Network Video Recorder

Version: V3.6.1 build161019

Release Note

(2016-11-4)

3. [Email]

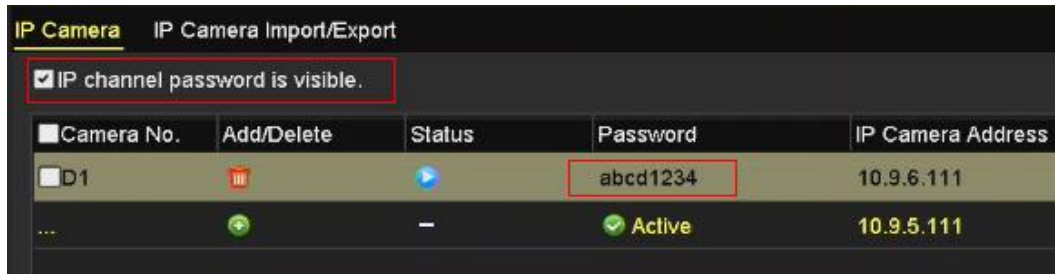
- (1) Optimize email attached picture strategy;
- (2) Add email test button in webpage.
